# **Addendum to STAR HFT proposal**

## **January 8, 2008**

**Figure 1: End view of the new PIXEL geometry. The figure shows the inner and outer sensor layers at their new locations of 2.5 cm and 8.0 cm, respectively.**

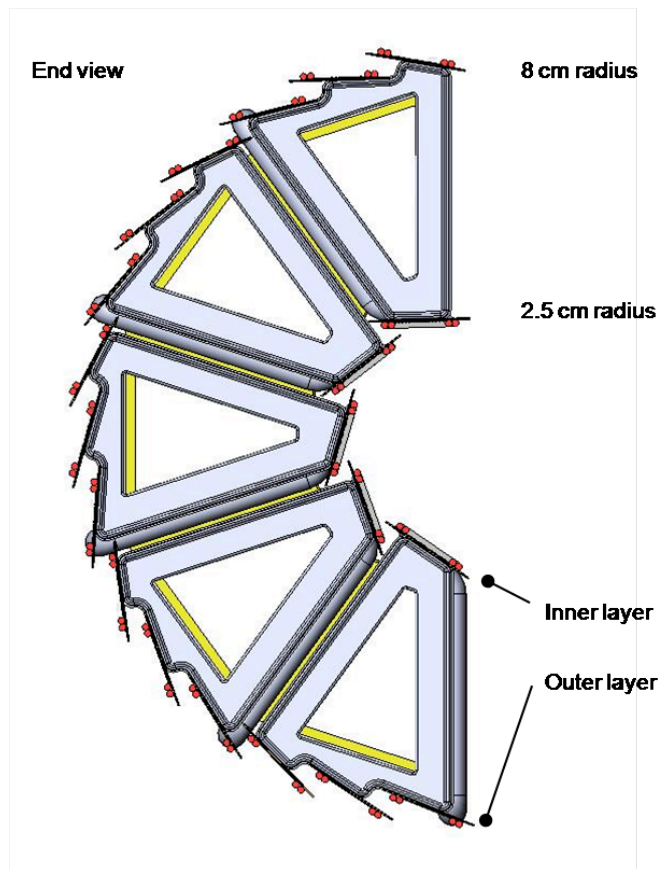
The support and geometry for the pixel sensors have been modified and the new layout is shown in Figure 1. The sensors will be mounted on a trapezoidal ‘box beam’ (similar to the ALICE and CMS detector designs) and we will no longer use individual ladders to support a row of sensors. Each carrier assembly now has 3 rows of outer sensors for each inner row of sensors. The inner layer of sensors will be located at 2.5 cm radius and the outer layer will sit at an average radius of 8 cm. This is a small increase over the ~7 cm outer radius quoted in the proposal.

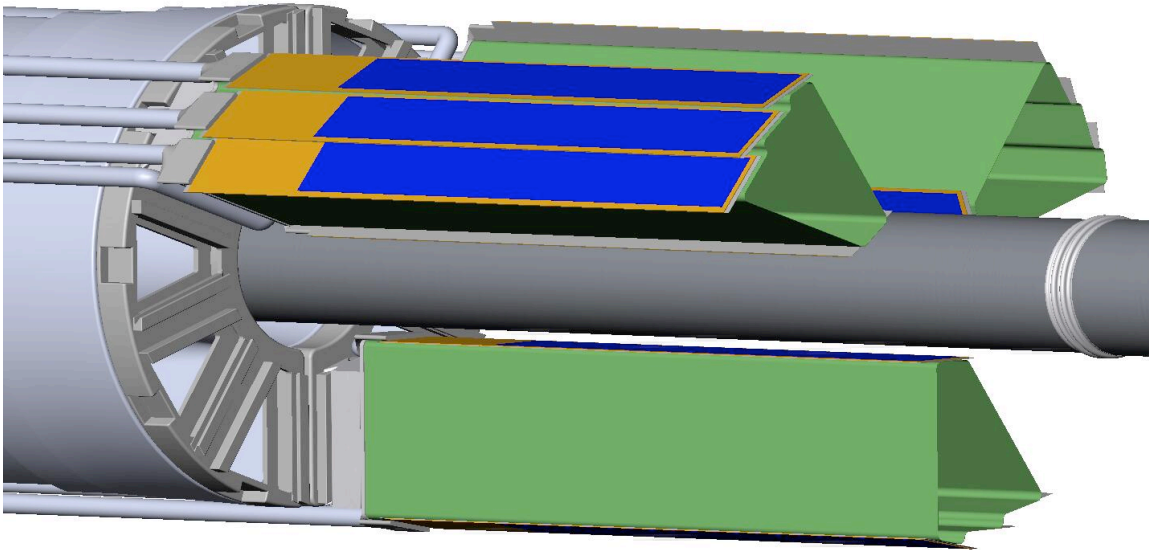
We have also changed the way the detector is assembled around the beam pipe. We have adopted a clam shell design rather than a three part assembly (section 4.8.1 page 105) which is easier to design and fabricate.

**Figure 3: Geometry of the new single layer IST. There are 23 ladders at an average radius of 14 cm; each with 11 Si sensor modules per ladder and 5 APV 25 readout chips per module.**

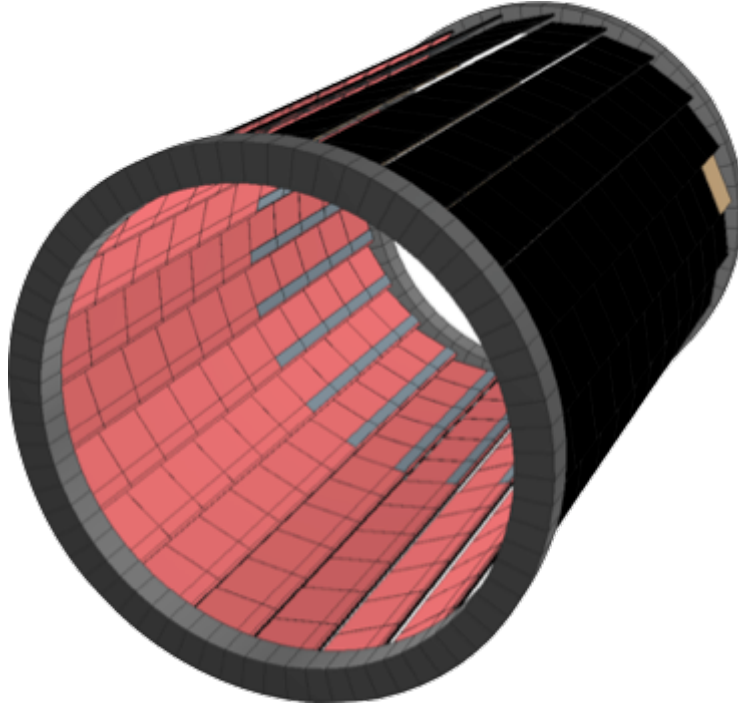
The old layout (proposal configuration) had three silicon layers at two radial locations. The new layout employs one layer of silicon at one radial location. This design minimizes the number of silicon layers and thus minimizes the number of channels (number of readout chips) and reduces the cost. The current design consists of a single layer at a radius of 14 cm, with 23 ladders, and has a length of 44 cm with 11 sensor modules per ladder. Each Silicon pad sensor has a double-metal-layer construction, AC coupled and with an overall size of 4 cm by 4 cm. The final structure is still being optimized; but pad dimensions of  $400\ \mu\text{m} \times 1\ \text{cm}$  are currently anticipated with 5 APV25-S1 readout chips per module. (Section 5.2 page 129-130).

The new configuration has many fewer sensors and readout chips and results in an overall reduction in heat load on the system; but the new scheme requires the use of the more expensive double-metal sensors. A schematic drawing of the new IST geometry and layout is shown in Figure 3.
